Project No. 23-2778

Re: Structural Observation — 458 Jamestown Dr, Spring Lake, NC 28390

PICTURE ADDENDUM

Picture 1 – 458 Jamestown Dr, Spring Lake, NC 28390

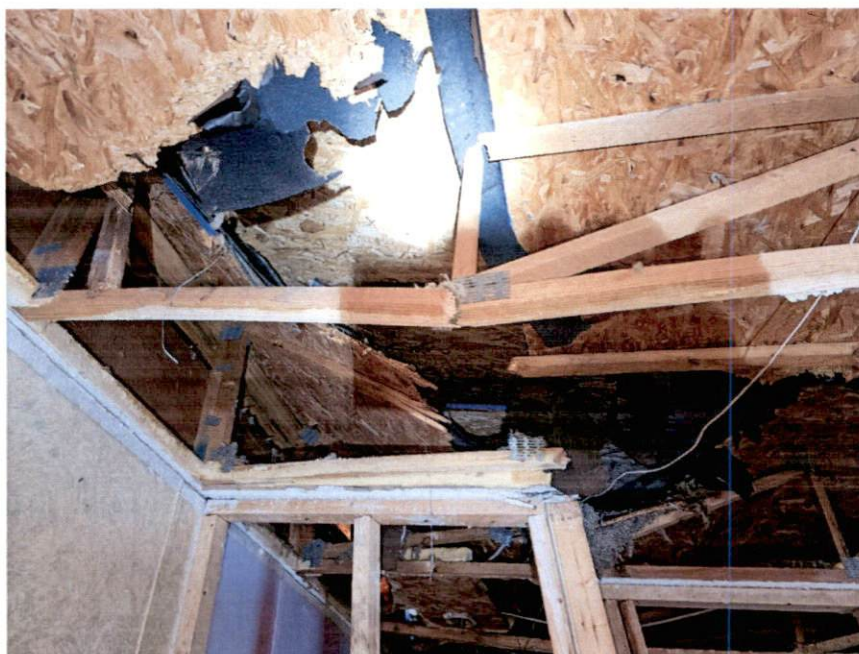
At your request, on November 29, 2023 we performed a visual structural observation of damaged roof framing from a reported tree impact at the Spring Lake residence noted above. The structure is a double wide manufactured home over a pier/curtain wall with interior masonry piers (see picture 1).

Detail 1 – Roof Sheathing Reinforcement

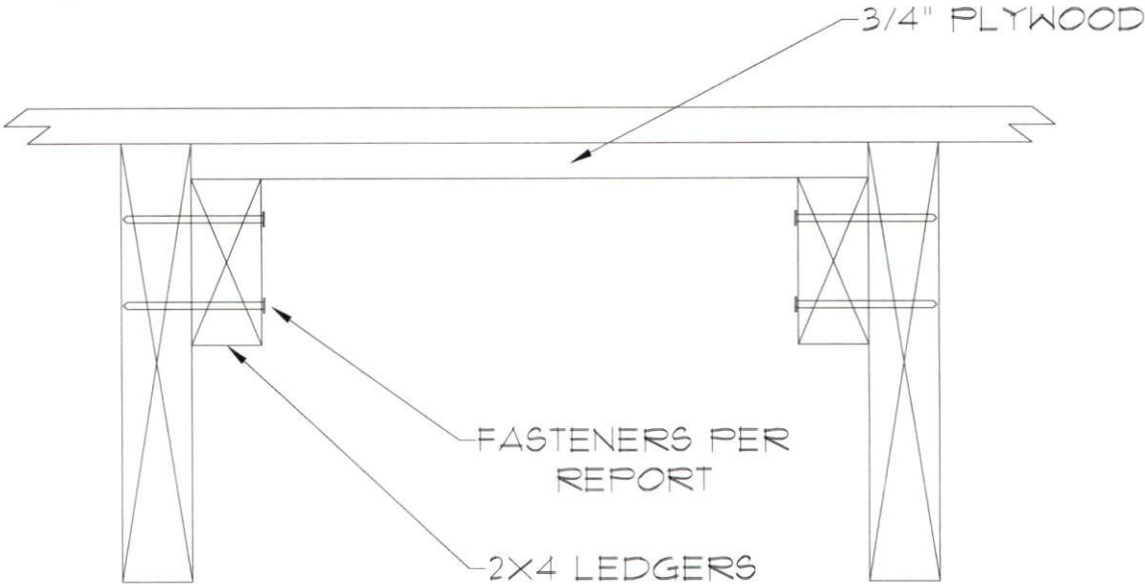
- 2) Areas of punctured roof sheathing should be reinforced with $\frac{3}{4}$ " plywood tight-fit to the underside of roof sheathing. Secure plywood with 2x4 ledgers securely fastened to parallel truss elements (*see detail 1*).
- 3) Remove and replace the damaged sections of the back left stud wall matching existing construction.
 - a) Any section of removed wall sheathing should be replaced with sheathing of matching thickness, fastened to wall framing members with 8d common nails at 6" o.c. at panel boundaries, and 12" o.c. to studs within the panel field. Splice panels over centerlines of wall studs as needed with $\frac{1}{8}$ " minimum edge nail distance. No section of new or remaining sheathing should be smaller than 2'-0" in any direction.
